QUATTROCCHI KWOK
ARCHITECTS

April 26, 2017

Franklin Elementary School Modernization– Schematic Design Meeting #2

ENLARGED 1ST FLOOR PLAN FRANKLIN ELEMENTARY SCHOOL

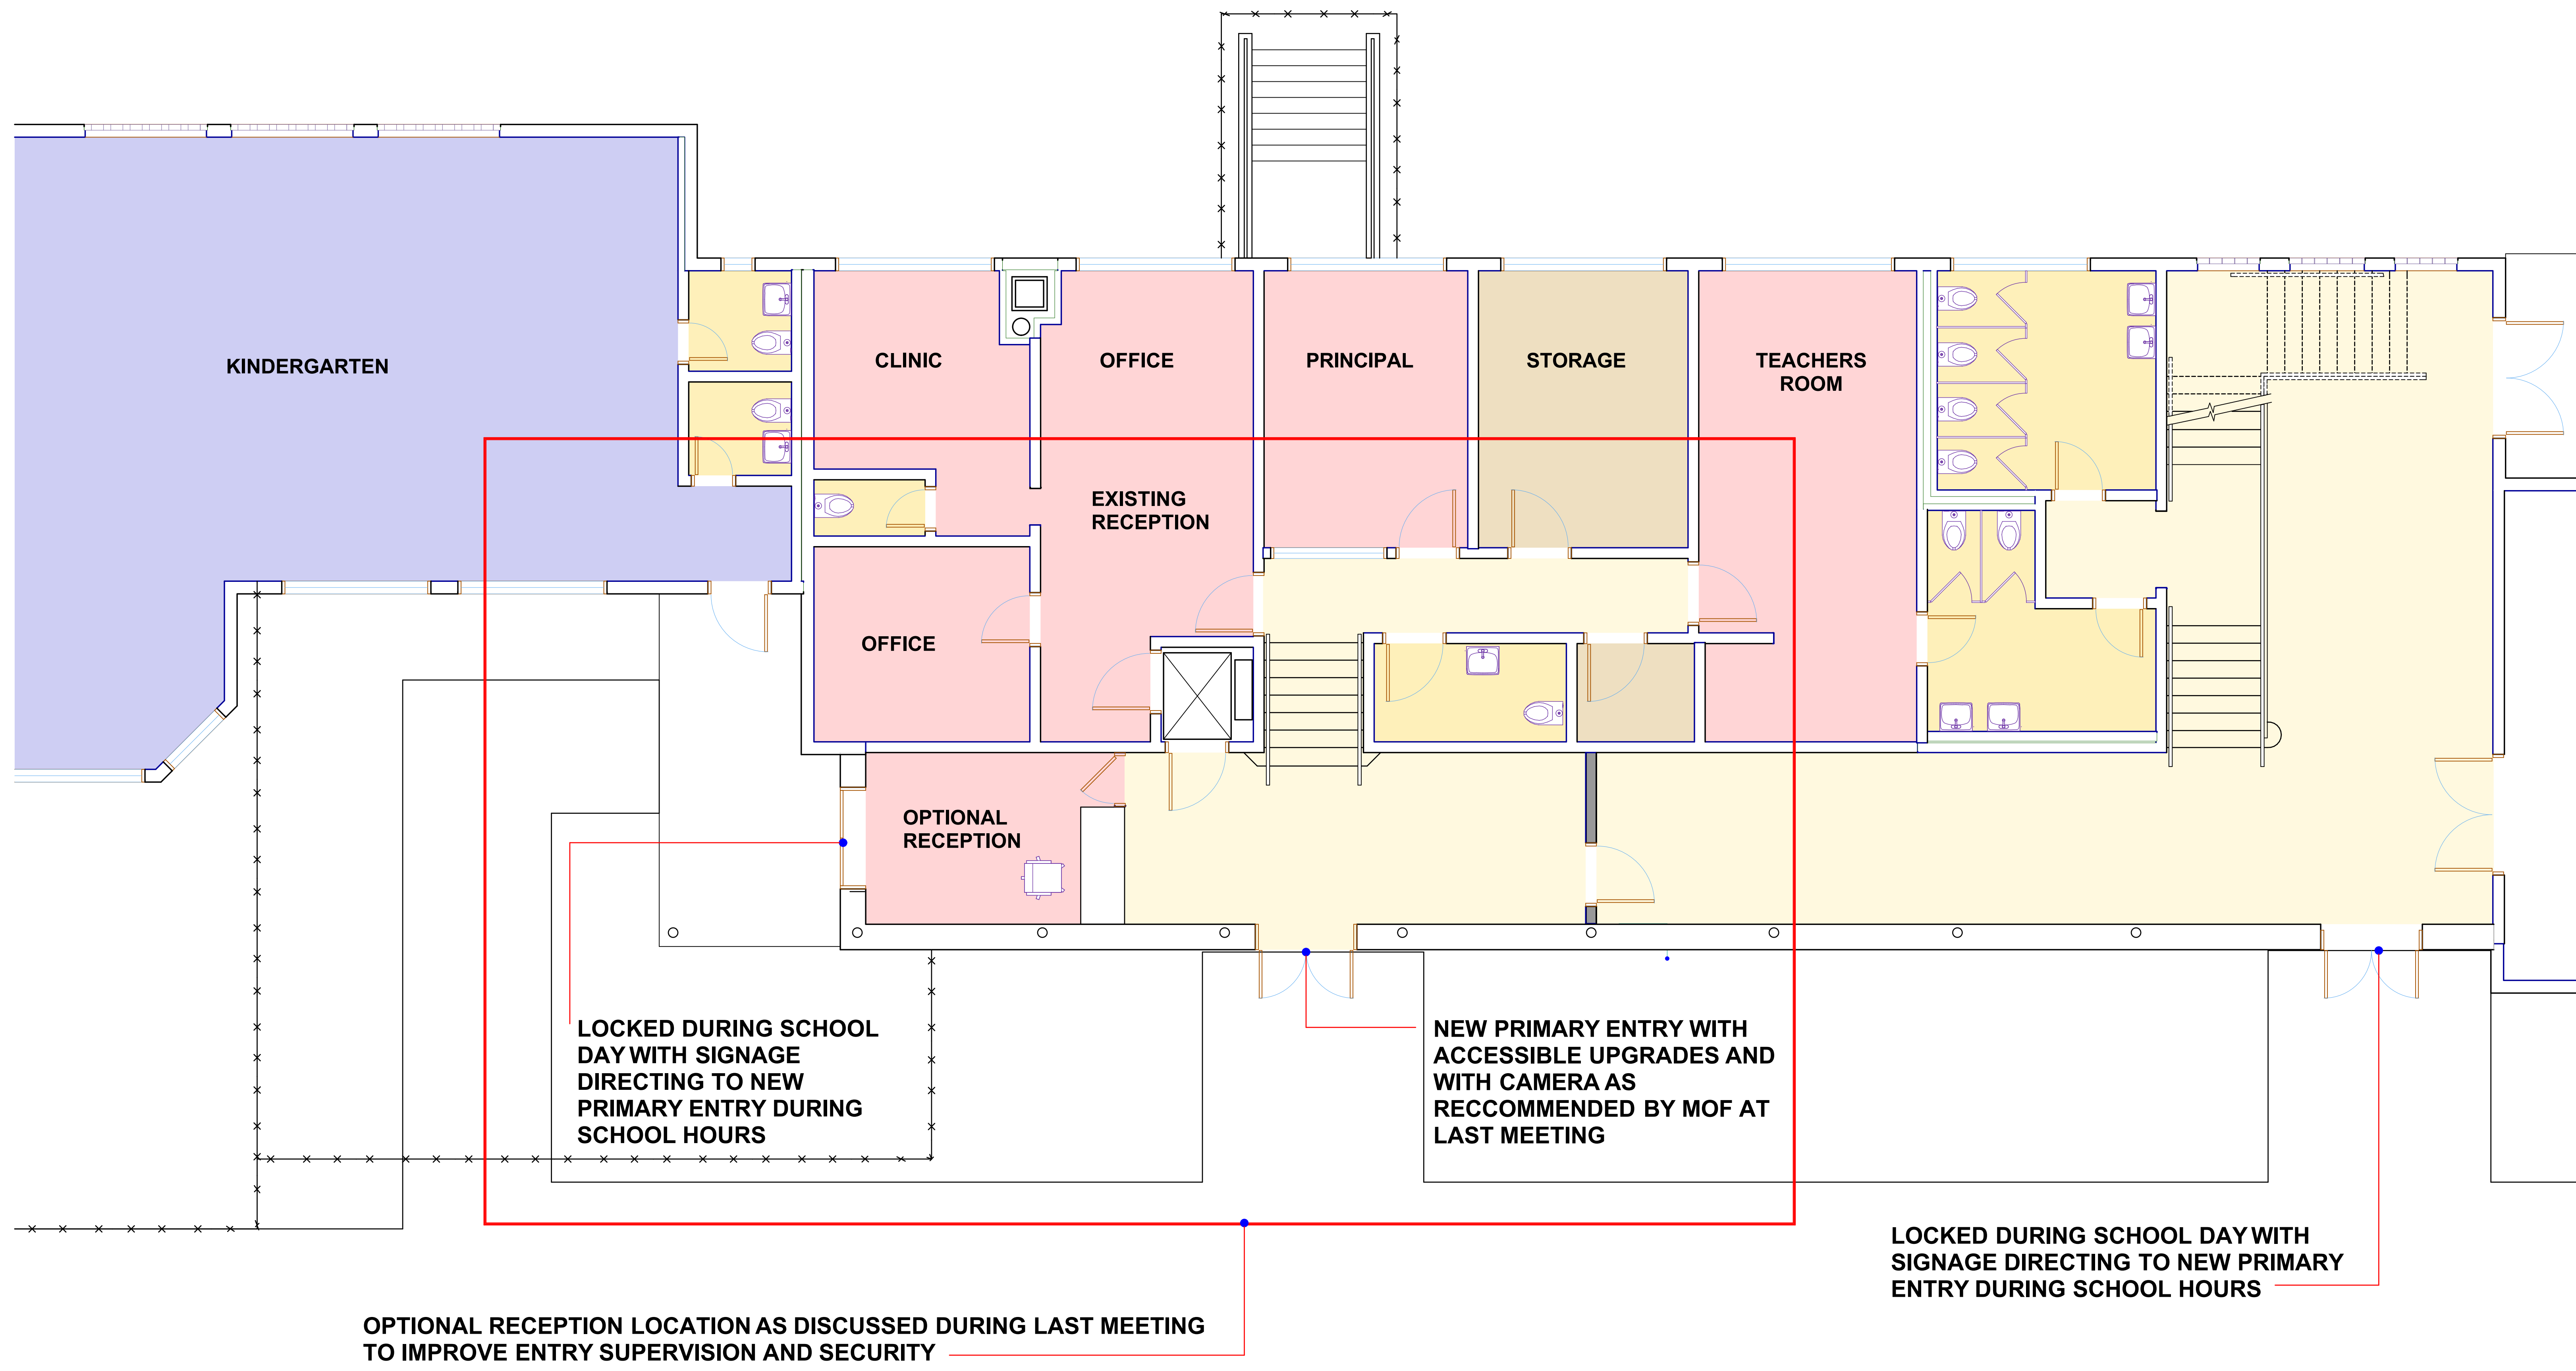
- Nick explains the new layout of the relocated reception area requested by the site committee at the previous meeting. This layout relocates the reception area to the main corridor adjacent to the entry door to the left face San Antonio Ave. This door will be the new main entry to the school. Other doors will be locked during school hours. The alternate to this layout would leave the receptionist at the current location and provide a camera at the entry door so the visitors could be screened and let in to the building.

- The Principal is concerned about the disconnect between the receptionist and herself, but then realizes that it will just be a matter of learning a new work flow.

- The Principal likes the idea of relocated the reception area because it could present an opportunity to create a conference space for more than 4 individuals.

- QKA will propose a new layout and present at the next meeting.
